Re: Response to Peer Review from Novus Environmental Inc. for Proposed Hidden Quarry in Rockwood, Ontario, dated April 8, 2013.

The comments in this letter are in response to the peer review of Mr. Scott Penton, of Novus Environmental Inc, dated April 8, 2013, regarding Aercoustics' Noise Impact Study¹.

Project: Hidden Quarry

Drawing Title: Daytime Sound Level Contours @ 4.5m Height Phase 3, Stage 2

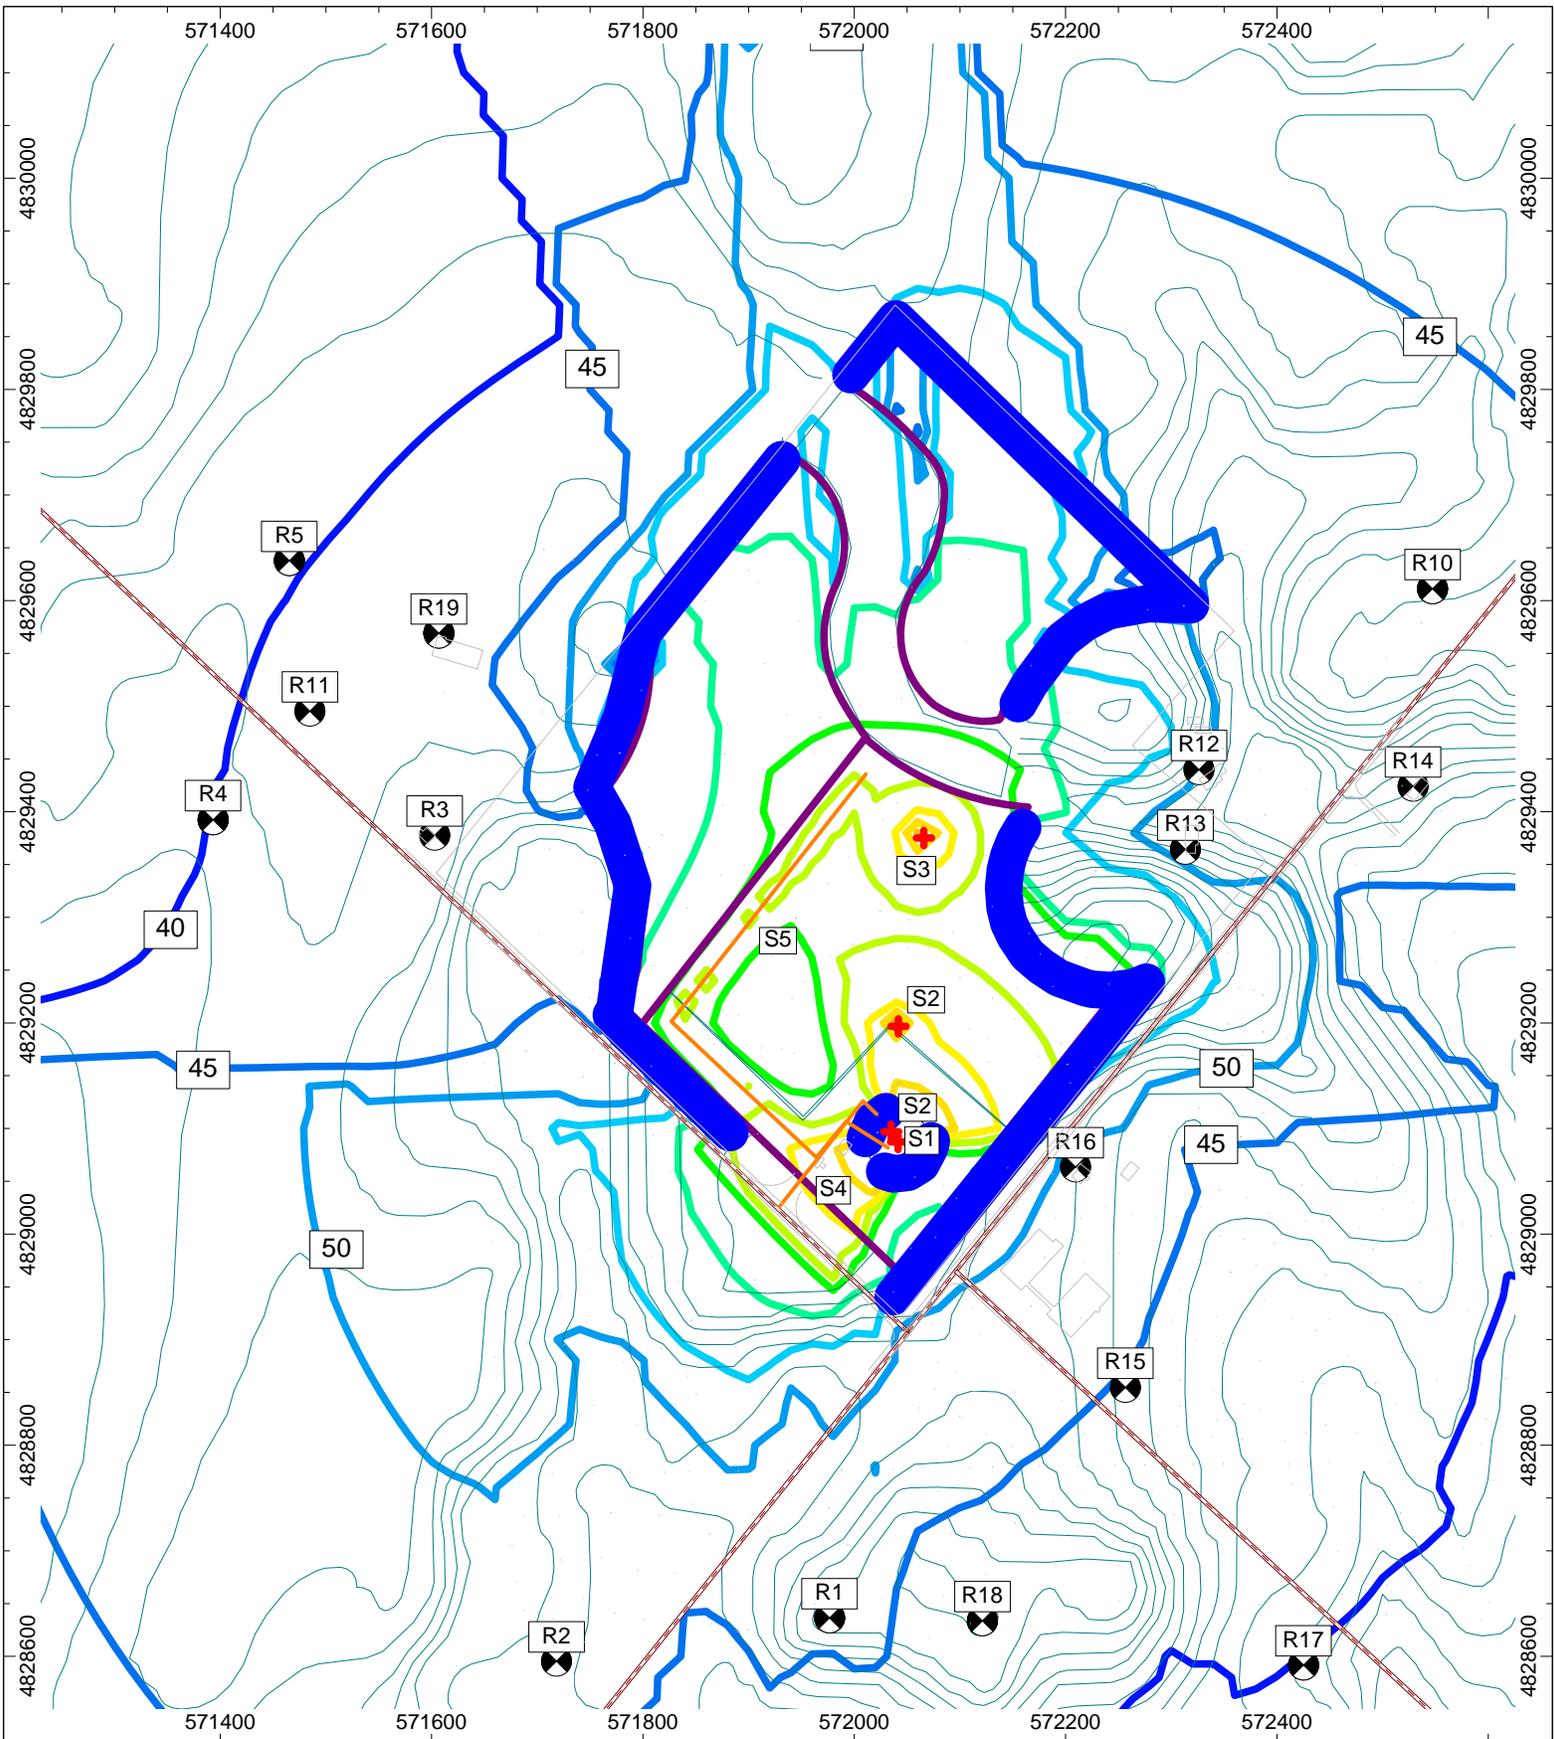
The AEL report notes that a receptor height of 1.5m was used in the assessment. This is inconsistent with both MOE NPC-205 and NPC-232 noise guidelines

The report does not indicate where source equipment is being located within the quarry for noise modelling purposes. A contour map is required to confirm that compliance is achieved at all points at ground level within 30m of dwellings.

Although Aercoustics disagrees with Novus' interpretation of the MOE guidelines with respect to daytime receptor heights, Aercoustics has verified that impacts from daytime quarry operations at a 4.5m receptor height for two-storey dwellings does satisfy the established daytime sound level limit criteria, with the implementation of the acoustic controls as recommended in our Noise Impact Study¹.

Aercoustics has attached sample daytime contours to this letter, generated at 4.5m, to validate the claims made in item 1 above.
